## Submission 1

**Re: Foreshore licence application FS007134 Sea Stacks Offshore Wind ESB**

**Figure 1.2 - Foreshore Licence Area proposed by ESB Wind Development Limited (in red)**

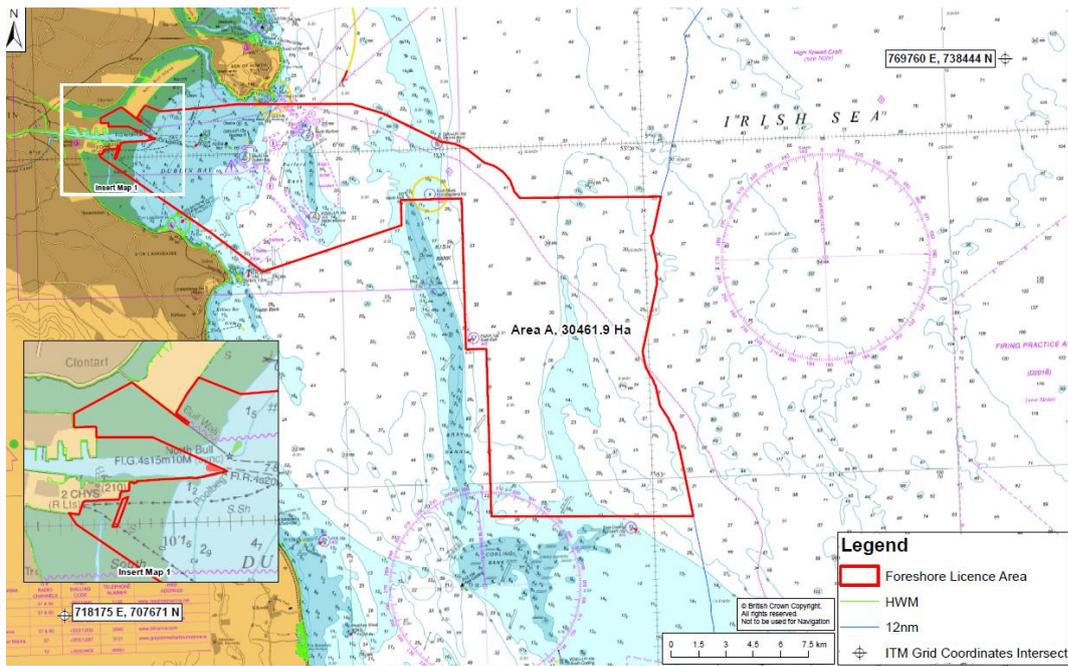
- 1.5 It is submitted that circa 80% of the Foreshore Licence Area proposed by ESB (see Figure 1.2) under the FLA SS FS007134 Application overlaps with the Foreshore Licence Area proposed by Ocean Winds (see Figure 1.1) under the Réalt na Mara FS007133 Application. Specifically, the array investigation area proposed by ESB falls wholly within the Foreshore Licence Area proposed by OW Ireland for the Réalt na Mara Project under the Réalt na Mara FS007133 Application. In addition, the cable investigation area proposed by ESB covers a significant portion of one of the potential cable route options for the Réalt na Mara Project located in the Northern Area at Poolbeg Substation.
